SUBJECT: NOMAD ALERT SERVICE BULLETIN ANMD-53-9

## ALERT SERVICE BULLETIN

FUSELAGE - RUDDER PEDAL GUARD -  
RELOCATION OF BRUSH SEALS (MOD N728)

Guards, Control Column And Pedals  
LH/RH  
Figure 1

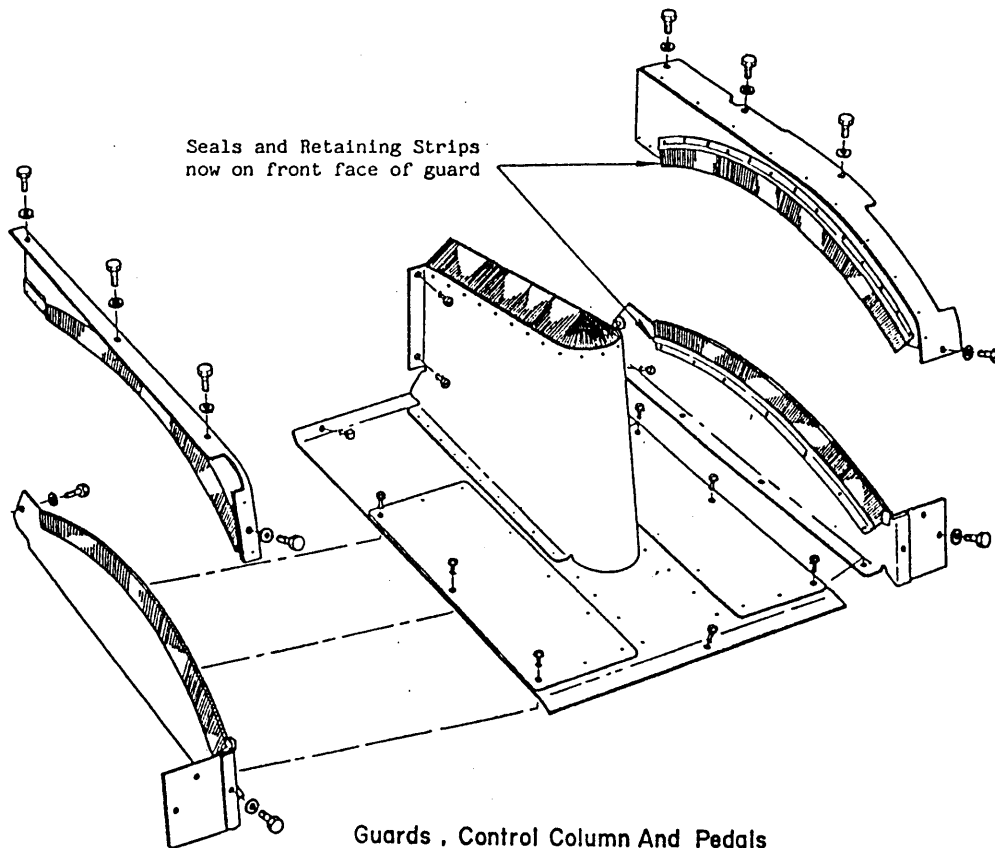
The bolt connecting the Brake Actuating Arm to the Pivot Arm caught on the Pilot's RH Rudder Pedal Upper Guard causing the pedal to jam in the forward position.

The upper and lower brush seals and their retaining strips are removed from the rear, or hidden faces of the rudder pedal guards, and re-located on the front, or visible faces. Attaching rivets are flush countersunk on the rear faces of the guards.

- D. Countersink the holes for the attaching rivets on the rear face of the guards (i.e. the hidden face when the guard is installed).
- E. Chamfer the edges of the curved slot on the rear face, approximately 0.03 inch by 45 degrees. Do not chamfer the end radii of the slot.
- F. Re-attach the brush seals and retaining strips using rivets such that the seals and retaining strips are now on the front face of the pedal guards, and the rivet tails are flush riveted in the countersinks on the rear face. (Refer Fig. 1)
